**TO:** Mills City Council  
**FROM:** Megan Nelms, AICP, City Planner  
**DATE:** April 8, 2025  
**SUBJECT:** Vinich Development Plan

**Case Number:** 25.01 DEV

**Vinich Development  
Commercial Development Plan**

# SITE PLAN LOTS 2 AND 3 SAGE ADDITION MILLS, WY

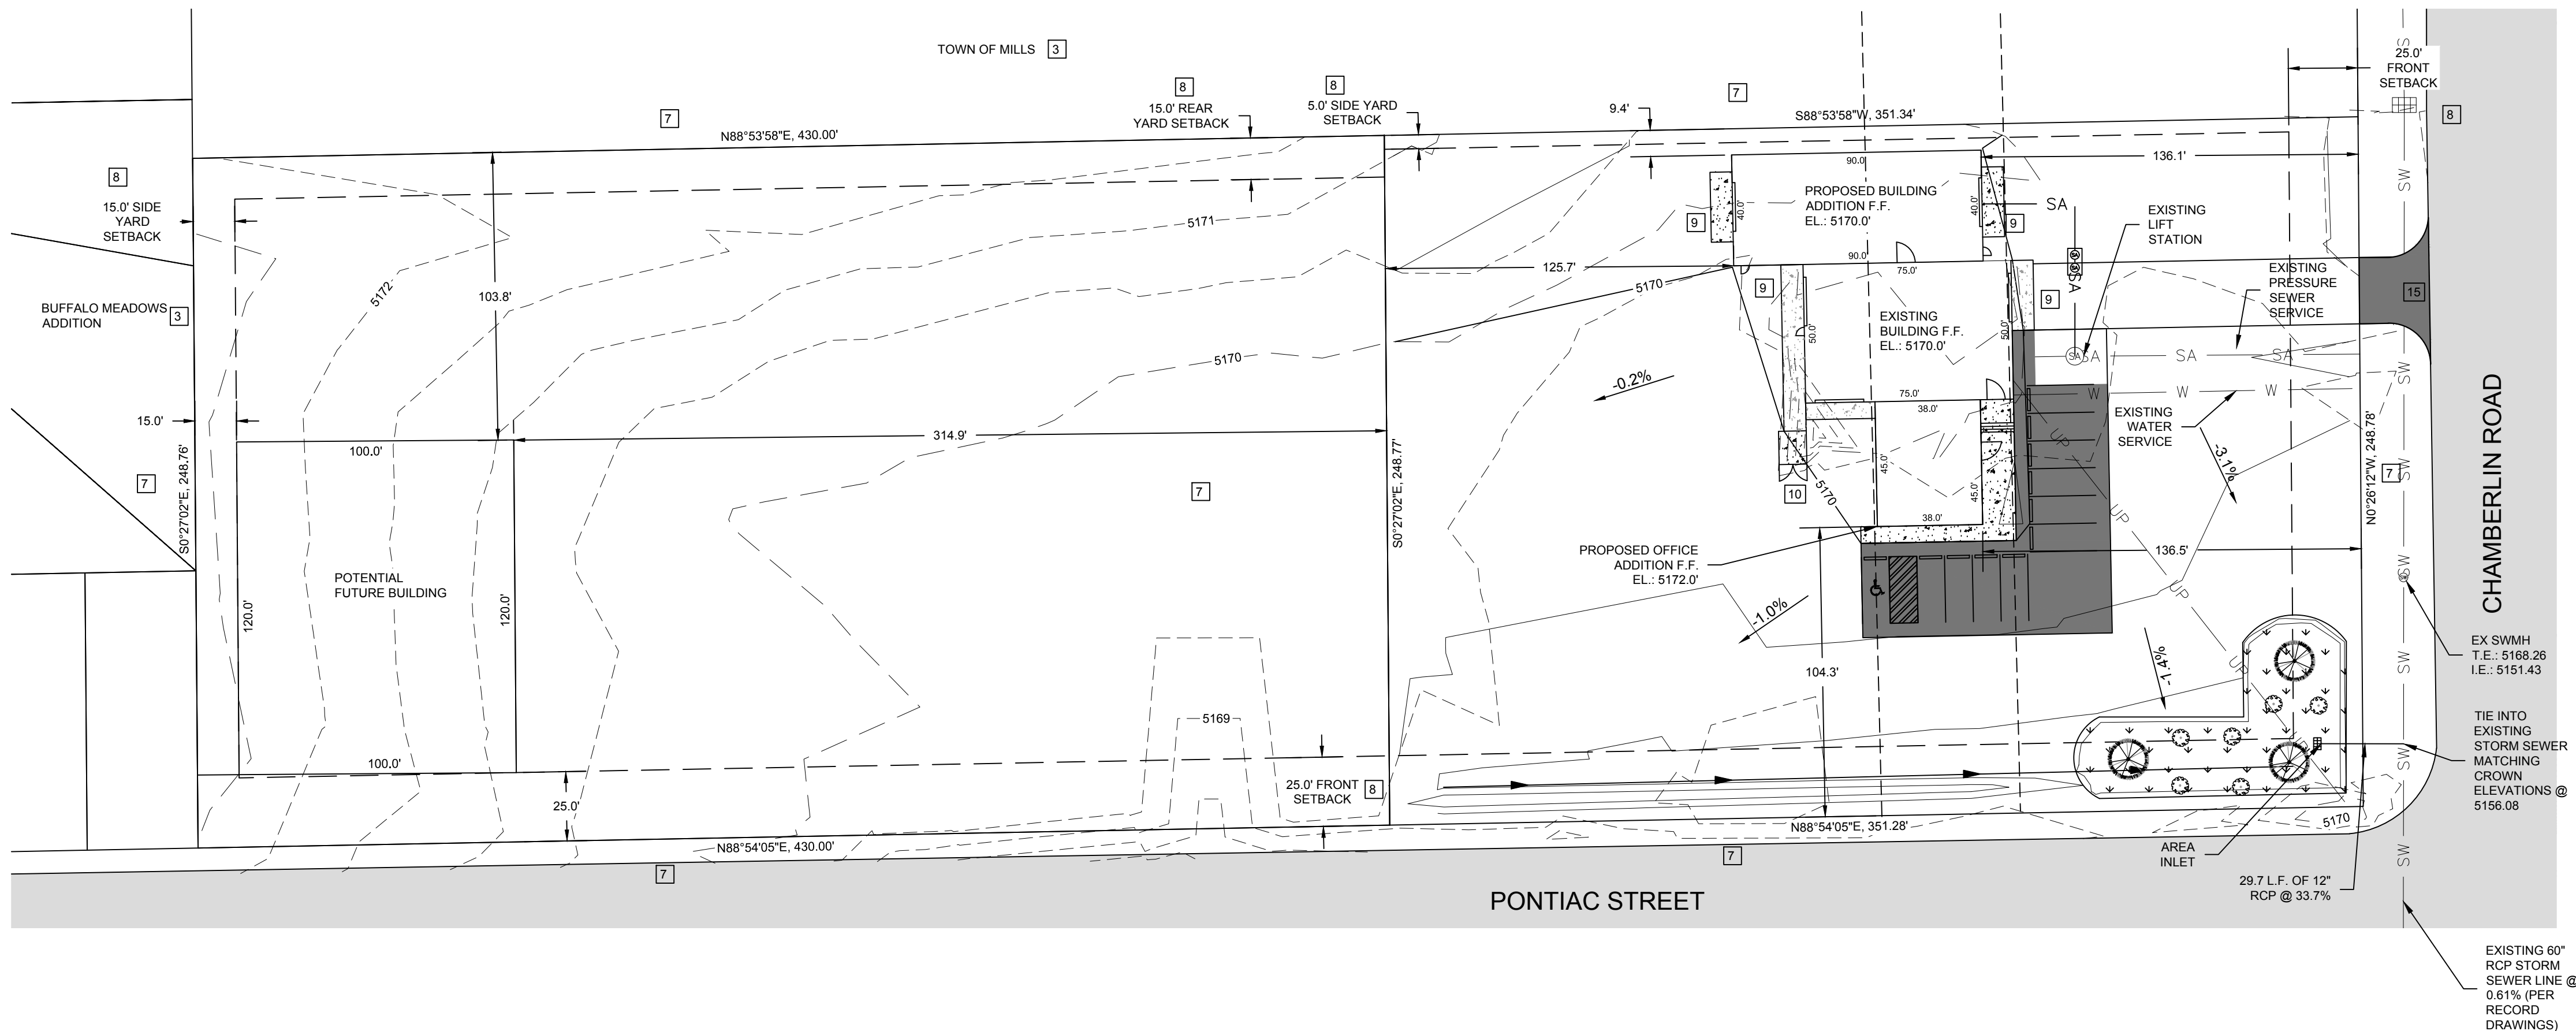
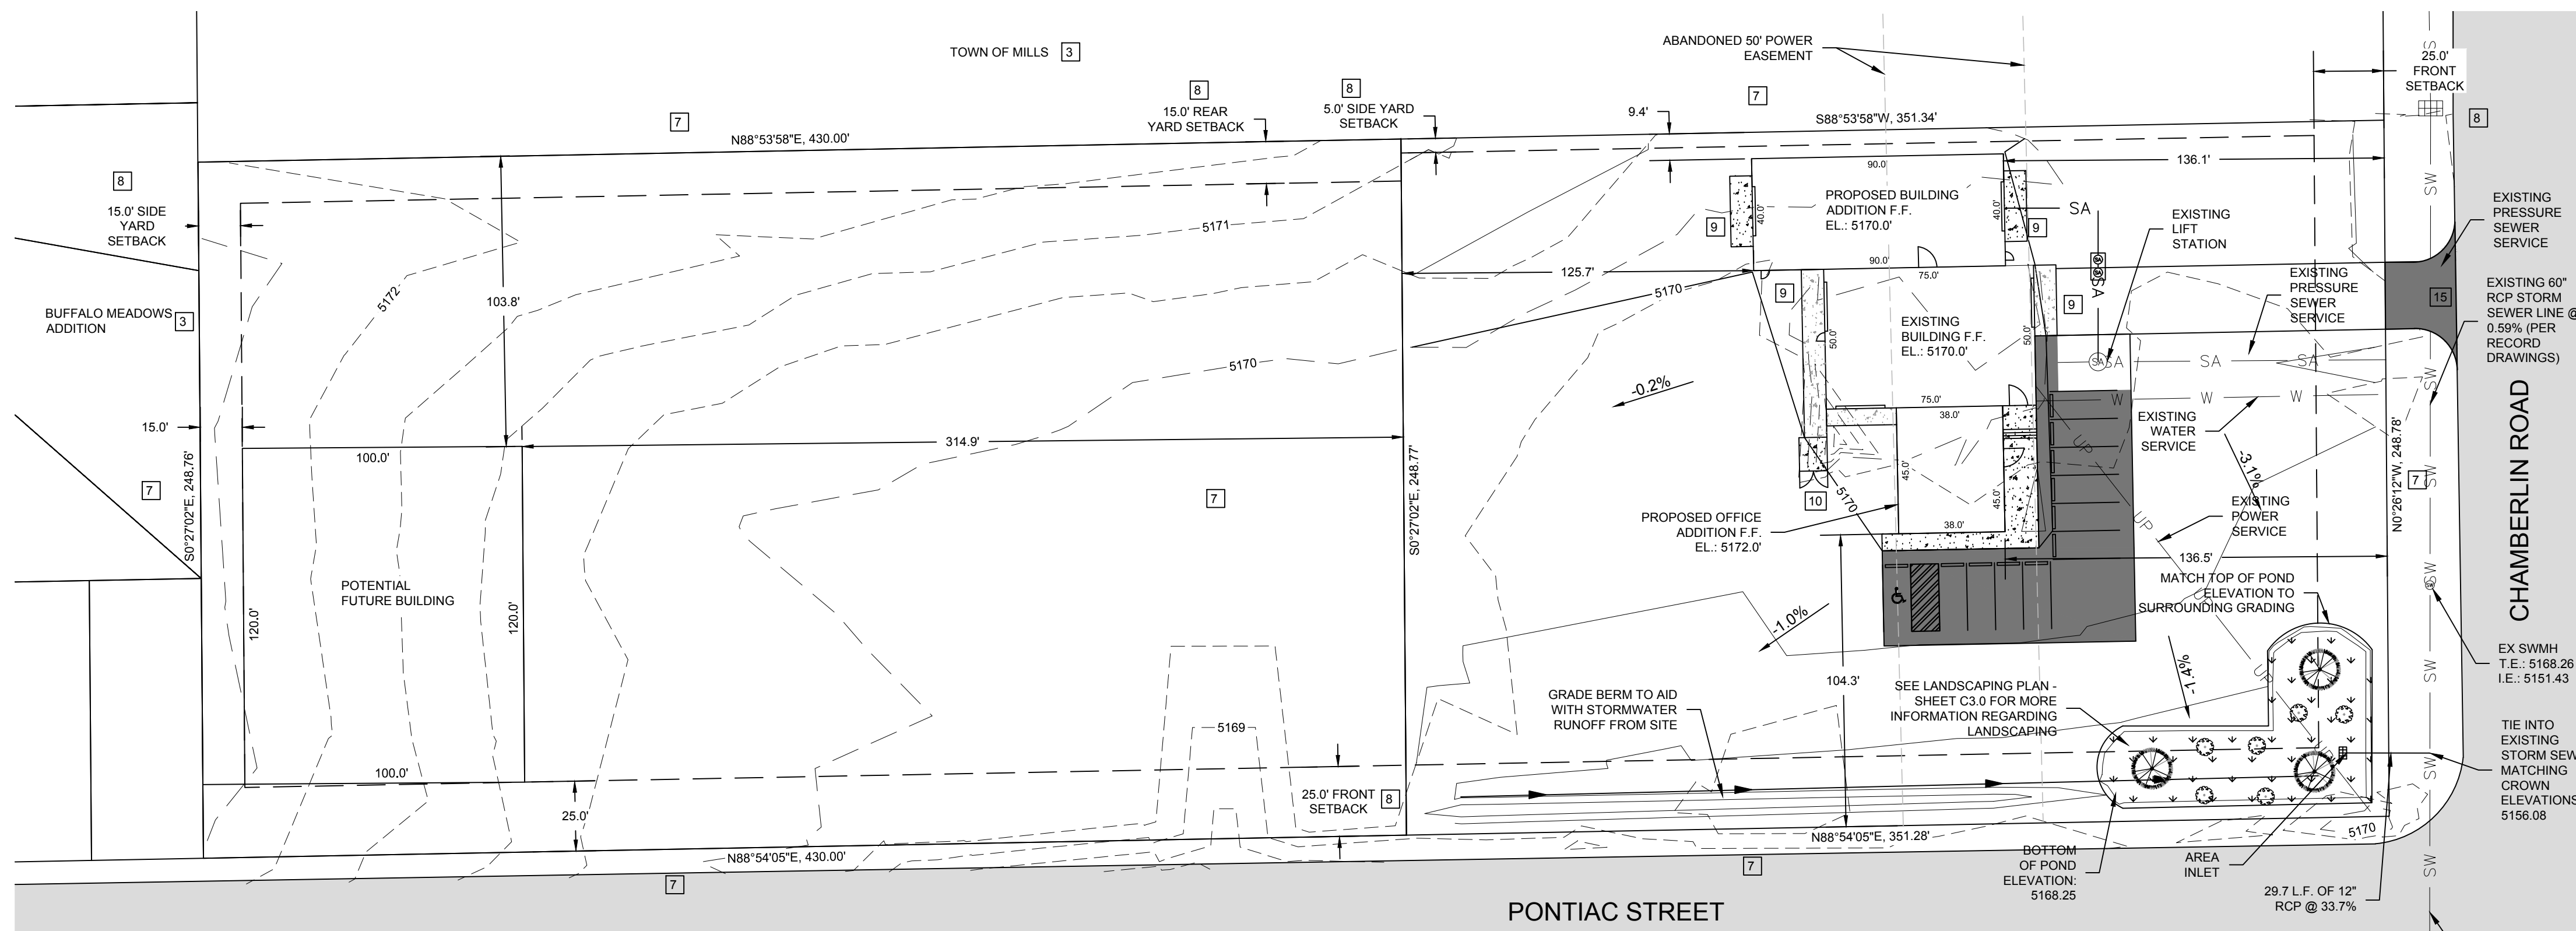
The development plan has been revised to show the location of the easement in relation to the existing and proposed structures. The existing structures are already constructed within the easement, however, for all intents and purposes, the easement is considered abandoned and its effect on future construction is negligible.

Per Section 40.40 of the LDRs, a minimum of 4% of the site must be landscaped. A landscaping plan for the property has been included with the submittal. The development plan notes that exterior lighting will be on the building, with no proposed parking lot illumination. Specifications for the types of exterior lighting for the building need to be provided.

A 'potential future building' is depicted on the adjacent Lot 3A. It should be noted that any future development on Lot 3A will require a separate Development Plan application and review. The applicant should also be aware of additional setbacks and buffering that will be required for commercial or industrial development adjacent to the residential Buffalo Meadows Addition.

1. Submit an exterior lighting plan per Section 40.35(4) showing the location and types of lighting for the building, along with manufacturer's specifications.
2. Per Section 40.10(6) all required parking spaces and all driveways, entrances and exits from the parking area shall be paved with asphalt, concrete or similar permanent surface.
  - a. Nine (9) parking spaces are required. 14 are shown on the development plan with asphalt surfacing. This meets the intent of the regulations.
3. Submit a final drainage plan
4. Show all existing easements on the site plan.
5. Enter into an approved Site Plan Agreement upon approval of the Development Plan.
6. Obtain all required building permits for:
  - a. All site lighting
  - b. All on-premise signage.
